TEMPORARY DRAINAGE PROPOSAL

APPLICATION SITE OF THE PROPOSED
TEMPORARY PLACE OF RECREATION, SPORTS OR
CULTURE (HOBBY FARM) FOR A PERIOD OF 3
YEARS AT LOTS 1430 (PART), 1431 (PART), 1439
(PART) AND 1440 (PART) IN D.D.114, SHEK
KONG, YUEN LONG, NEW TERRITORIES

APPENDIX F
RESPONSE TO COMMENTS

1. Comments from DSD/MN on 3 April 2023

APPENDIX C
PROPOSED DRAINAGE PLAN

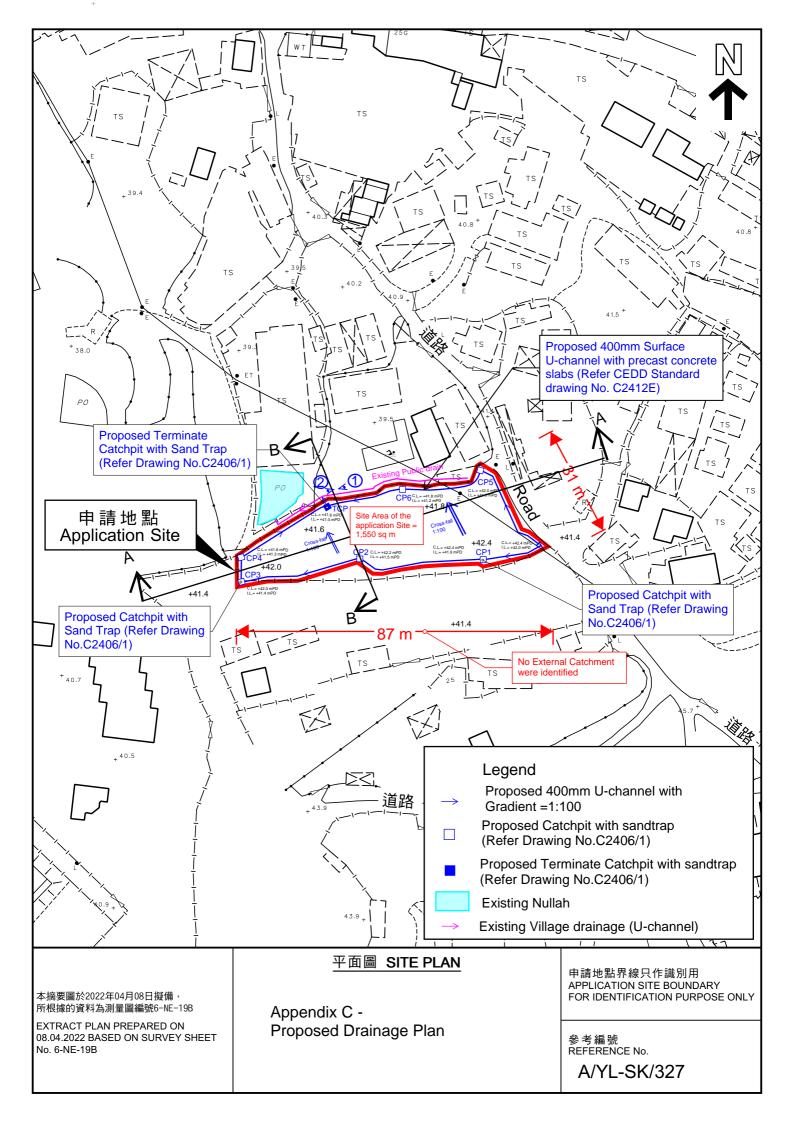
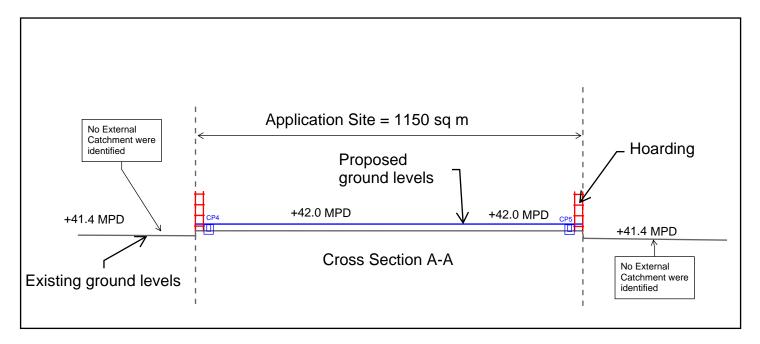
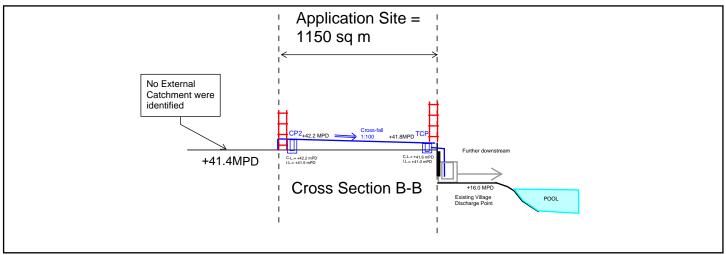
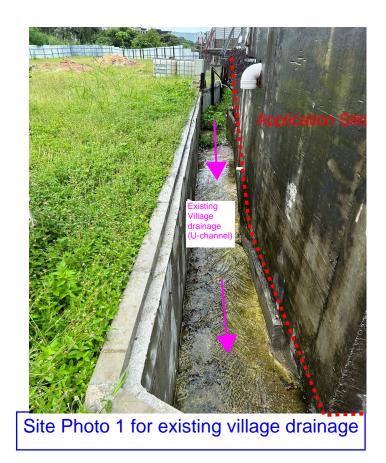
No.	Comments	Response
1.	Peripheral surface channels shall be provided along the site boundary to collect the surface runoff accrued on the application site and to intercept the overland flow from the adjacent lands.	Noted and agreed. 400mm U-channel are provided along the site boundary to convey stormwater leading to the existing village drainage system. Please refer the captioned Temporary Drainage Proposal and the proposed drainage plan in the Appendix C for your consideration.

5.	Please indicate clearly the full alignment of the discharge path from the application site all the way down to the ultimate discharge point (e.g. a well-established stream course/public drainage system).	For the full alignment of the discharge path from the application site, please refer to the Appendix C – Proposed drainage plan.

6.	The gradients of the proposed U-channels should be shown on the drainage plan,	Noted and provided. Please refer to Appendix C - Proposed drainage plan.

7.	The proposal should indicate how the runoff (the flow direction) within the site would be discharged to the proposed u-channel.	Noted and provided. Please refer to Appendix C - Proposed drainage plan.

8.	The cover levels and invert levels of the	Noted and provided. The invert levels,

9.	Cross sections showing the existing and proposed ground levels of the captioned site with respect to the adjacent areas should be given.	Noted and provided. Please refer to Appendix C - Proposed drainage plan.

10.	Sand trap or provision alike should be provided before the collected runoff is discharged to the public drainage facilities.	Noted. Terminate catchpit with Sand traps is to be provided before discharging to the downstream village drainage facilities, to prevent blockages and for regular maintenance purpose. Please refer to Appendix C - Proposed drainage plan.

No.	Comments	Response
	proposed u-channels, catchpits/sand traps should be shown on the drainage plan.	gradients and dimension of the proposed u- channels had been indicated in the Appendix C - Drainage Plan.

TYPICAL STANDARD DRAWINGS OF U-CHANNEL AND CATCHPIT

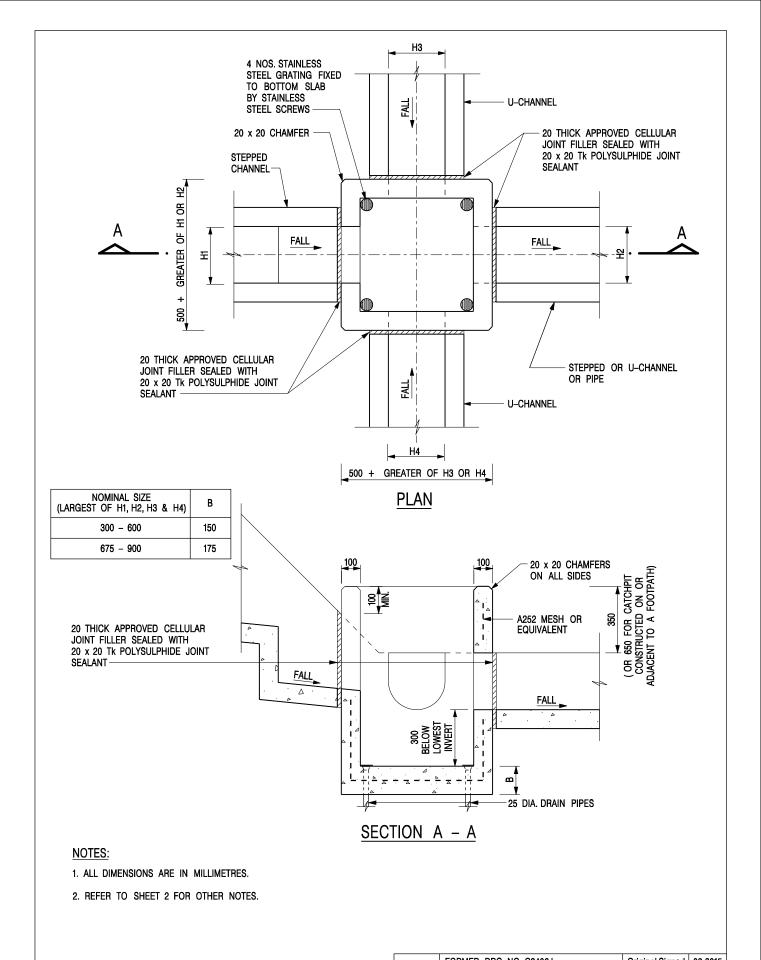
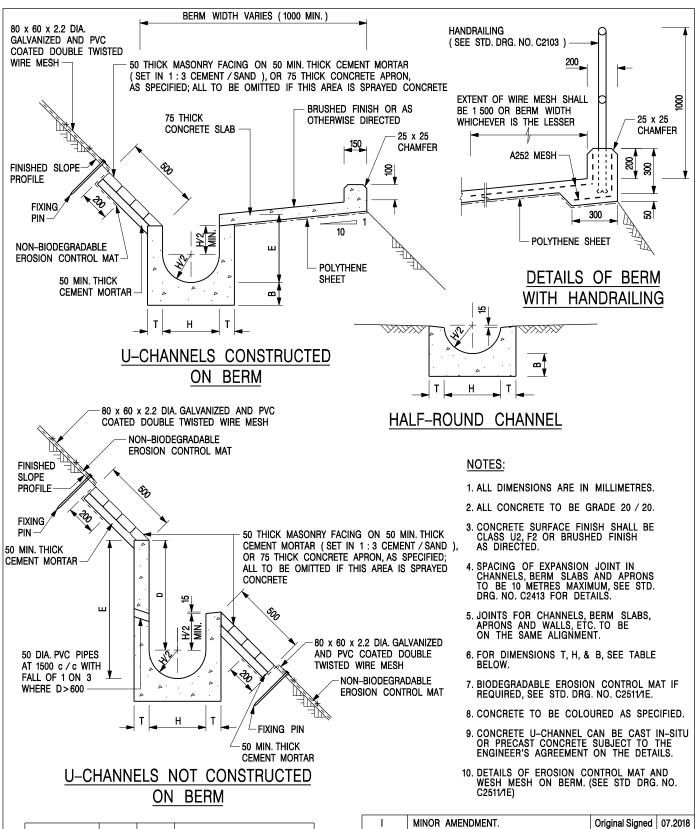
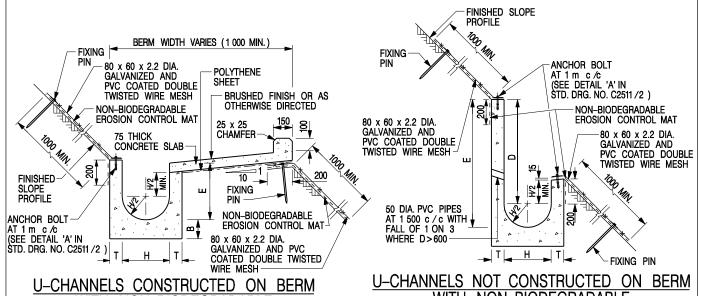
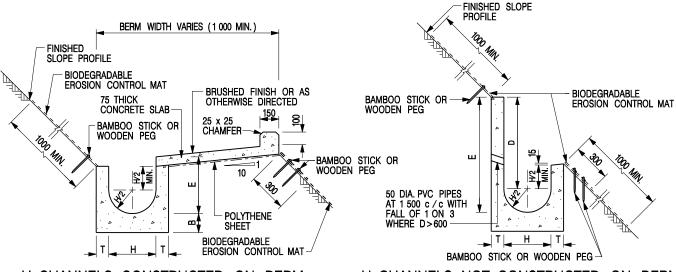
11.	Standard details should be provided to indicate the sectional details of the proposed u-channel and the catchpit/sand trap.	For the Standard details, please refer to the Appendix E - Typical Standard Drawings of U-Channel and Catchpit.
